COA # 2010-COA-483 (ONS)	INDIANAPOLIS HISTORIC PRESERVATION COMMISSION STAFF REPORT	Hearing Date DEC. 1, 2010
1505 N Delaware Street OLD NORTHSIDE		New Case
Applicant JOANNA TAFT mailing address: 1505 N Delaware Street Indianapolis, IN 46202 Owner: Redeemer Presbyterian Church 1505 N Delaware Street Indianapolis, IN 46202		Center Twp. Council District 15 Doris Minton McNeil
CASE		
COA: 2010-COA-483 (ONS) Alteration of west elevation (1960's portion) Installation of new patio area		
STAFF RECOMMENDATION: Approval

STAFF COMMENTS

2010-COA-483 (ONS):

Proposed/Patio Plan
1/4"=1'-0"

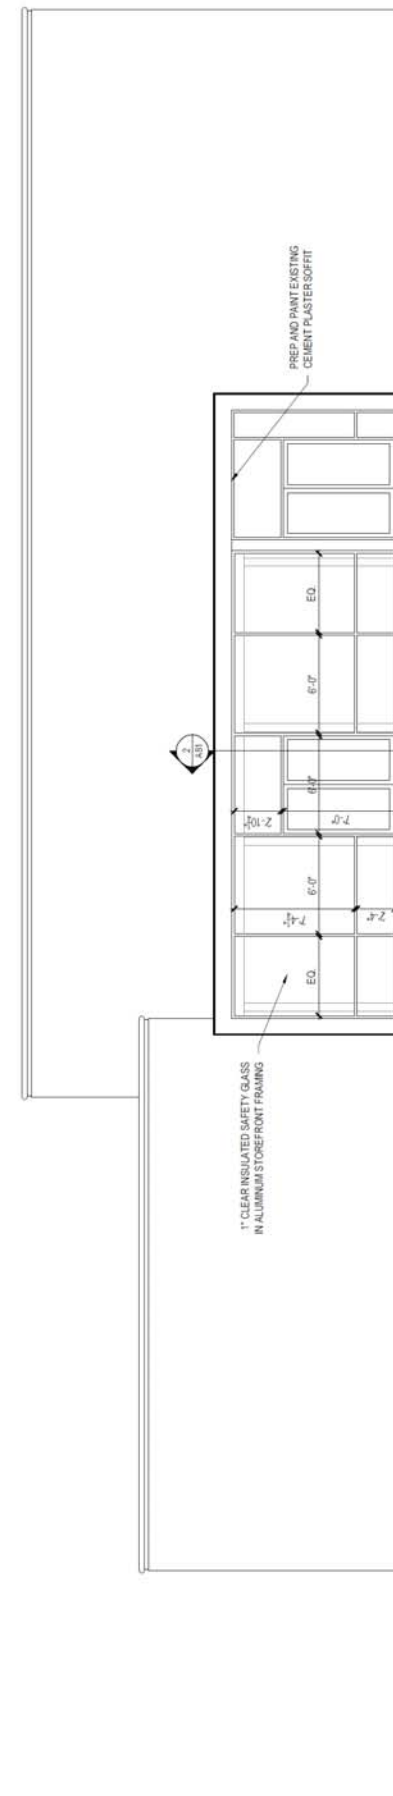
New Patio Area

The proposed new patio area in front of the new storefront system is to be stamped colored concrete with a smooth concrete border. The size of the patio area is roughly 22 feet by 39 feet. The area will contain patio furniture and outdoor space for the Urban Living Center. Landscaping will be provided.

Approval of a Certificate of Appropriateness to alter the west façade of the 1961 addition and install a new patio area, all per submitted documentation and subject to the following stipulations:

1. **Construction must not commence prior to approval by IHPC staff of final construction drawings and site plan. *Approved:_____ Date:_____***
2. **A pre-construction meeting between IHPC staff, the designer, the owner, and the contractor/construction manager must be held prior to commencement of construction. *Approved:_____ Date:_____***
3. **The proposed patio must be field-staked with no offsets and reviewed by IHPC staff prior to commencement of construction. *Approved:_____ Date:_____***
4. **Any changes to the approved design shall be approved by IHPC staff prior to starting work.**

Proposed West Elevation
1/4"=1'-0"

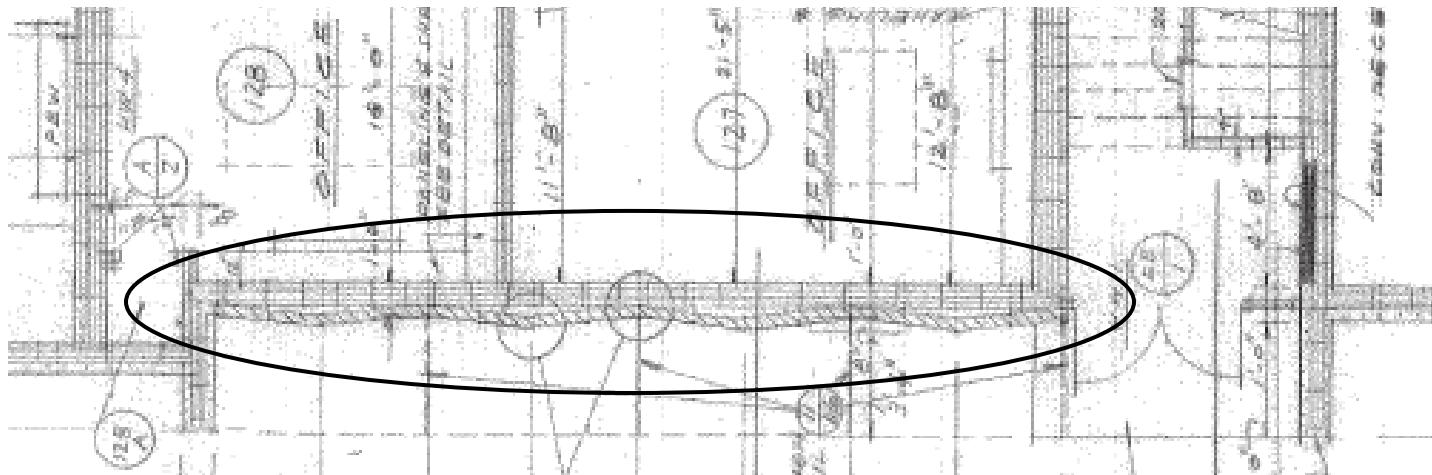
The Harrison Center for the Arts would like to make the Delaware entrance the main entrance, and to make it more open and friendly to the street and the neighborhood. They propose doing this by removing the original infill within the framed recess and replacing it with an aluminum and glass storefront system. They propose installing a patio area outside the new opened-up recessed area and a sign identifying the Urban Living Center above the recessed area.

6. While removal of the in-fill brick wall panel will result in a loss of a significant architectural and design feature, its replacement with glass will result in a significant benefit, worthy of making a compromise. Specifically, it will help to assure the long-term viability of this community-oriented use in a building that otherwise might have problems attracting a profitable use.
